Salem Nuclear Generating Station Unit 1  
Facility Operating License No. DPR-70  
NRC Docket No. 50-272

**SUBJECT: RAI RESPONSE, STEAM GENERATOR TUBE INSPECTION  
REPORT - EIGHTEENTH REFUELING OUTAGE (1R18)**

REQUEST FOR ADDITIONAL INFORMATION  
REGARDING STEAM GENERATOR TUBE INSPECTIONS CONDUCTED  
DURING THE SPRING 2007 REFUELING OUTAGE AT  
SALEM NUCLEAR GENERATING STATION, UNIT NO. 1  
DOCKET NO. 50-272

Figure 6-1  
SG11 Bobbin Depth Growth Rates

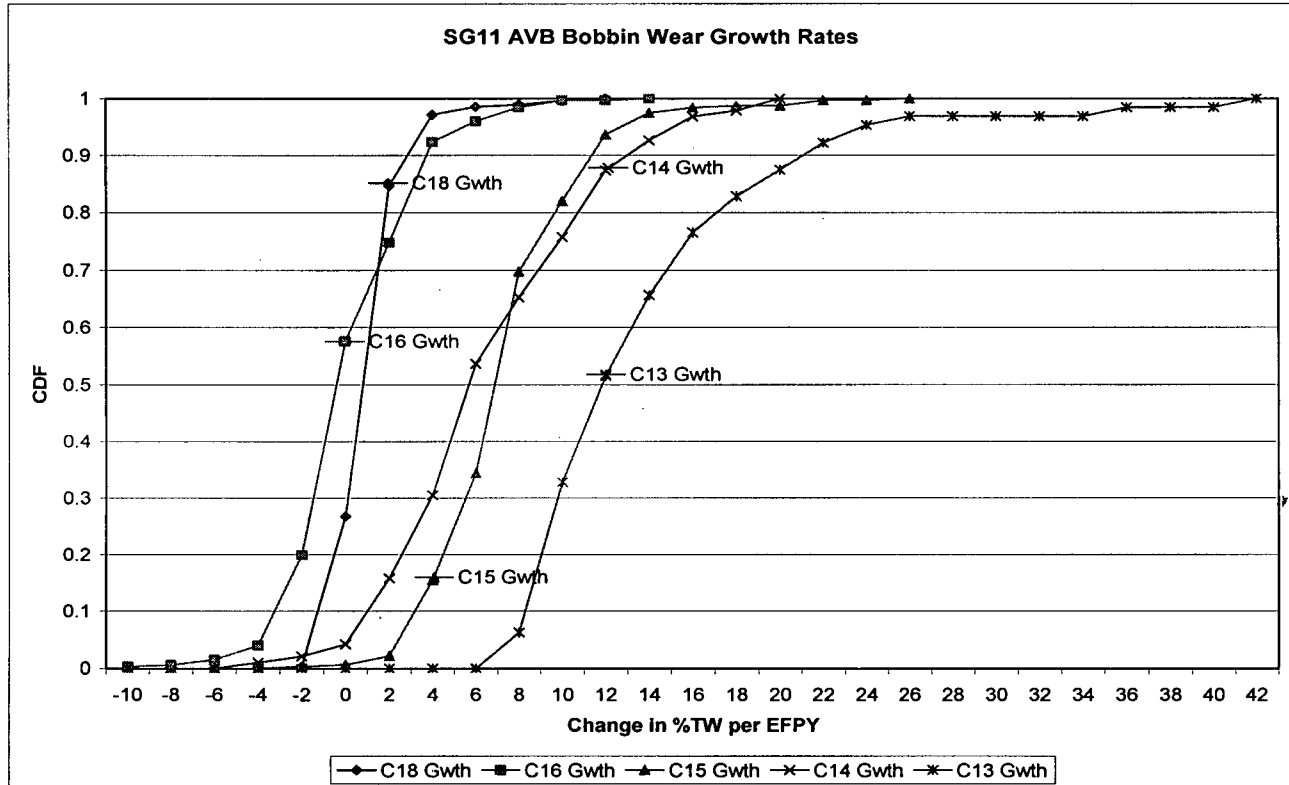
6. Please summarize the basis for your 32-percent through-wall repair criterion for wear at the AVBs. The NRC staff notes that the indication in SG 13 in row 54, column 65 at the 3rd AVB grew from 27-percent through-wall to 71-percent through-wall over two cycles. This indication exceeded your 63-percent condition monitoring limit (although the tube had adequate integrity). If one were to assume that similar growth could occur in other tubes, it would appear that a repair criterion less than 27-percent through-wall should have been implemented if the goal is to operate more than one cycle between inspections. The NRC staff also notes that although this tube had integrity it could be because the material properties of the specific tube were higher than those used during the

Past inspection results show that growth rates, in general, have become less severe with each successive inspection. This point is demonstrated below in Figures 6-1 through 6-4. These figures show that in general the overall growth rates (especially the more critical upper tail region of the curve) has shifted to the left with each successive inspection. This demonstrates that the majority of AVB wear growth is decreasing over time. Even though the trend is a decrease in growth rate, the EPRI SG Integrity Assessment Guidelines Rev 2, Section 5.2, indicates that low degradation growth rates in the last inspection should not be favored over prior cycle data with larger growth rates until an additional cycle of low growth data has been obtained for added assurance of the low growth trend. Therefore, compliance with EPRI SG Integrity Assessment Guidelines Rev 2 points to the use of the cycle 16 growth rates for the current operational assessment. Both SG13 and SG14 exhibit equivalent upper 95th percentile growth rates, yet SG13 was selected to model the growth behavior due to the better data fit in the upper tail part of the curve. For added conservatism, the SG13 cycle 16 growth rates were used to make OA projections for each of the four steam generators in cycles 19 and 20.
